DEPARTMENT OF TRANSPORTATION

RE: Preliminary Plan No. 11995042E

Clarksburg Town Center

REVISED LETTER

RE: Clarksburg Town Center

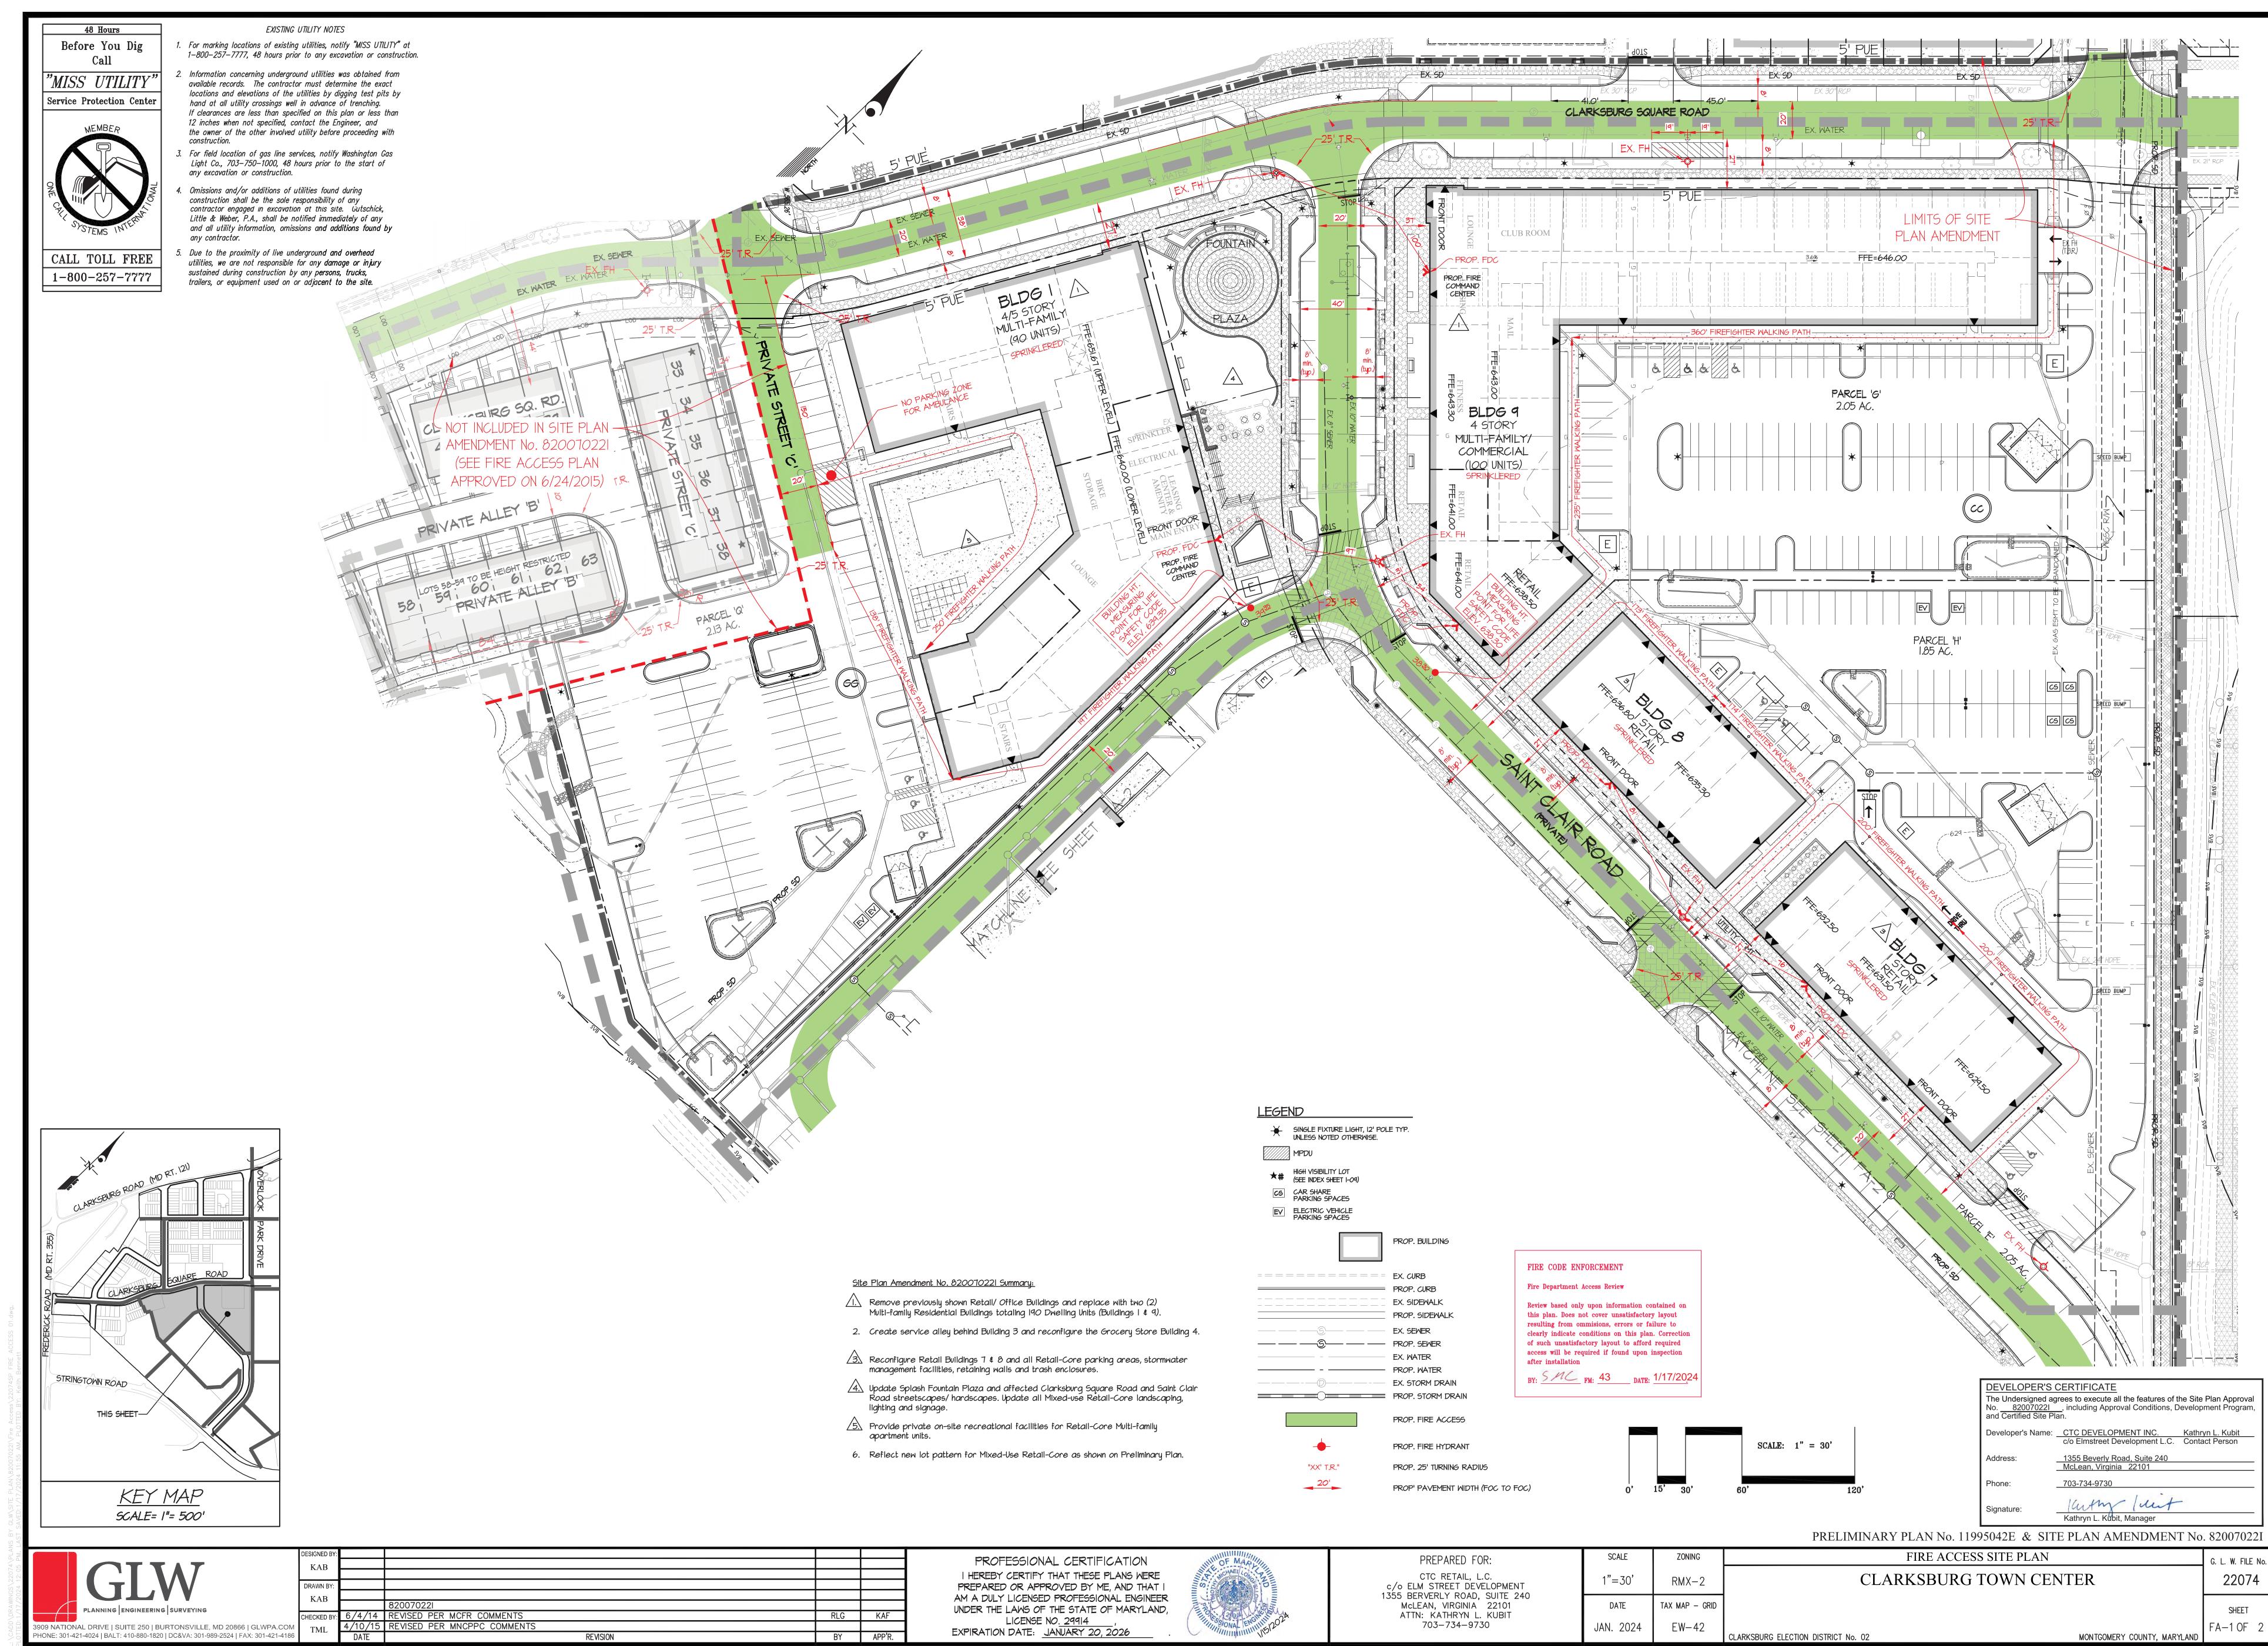
PLAN APPROVED

1. Review based only upon information contained on the plan submitted 17-Jan-24 .Review and approval does not cover unsatisfactory installation resulting from errors, omissions, or failure to clearly indicate conditions on this plan.

2. Correction of unsatisfactory installation will be required upon inspection and service of notice of violation to a party responsible for the property.
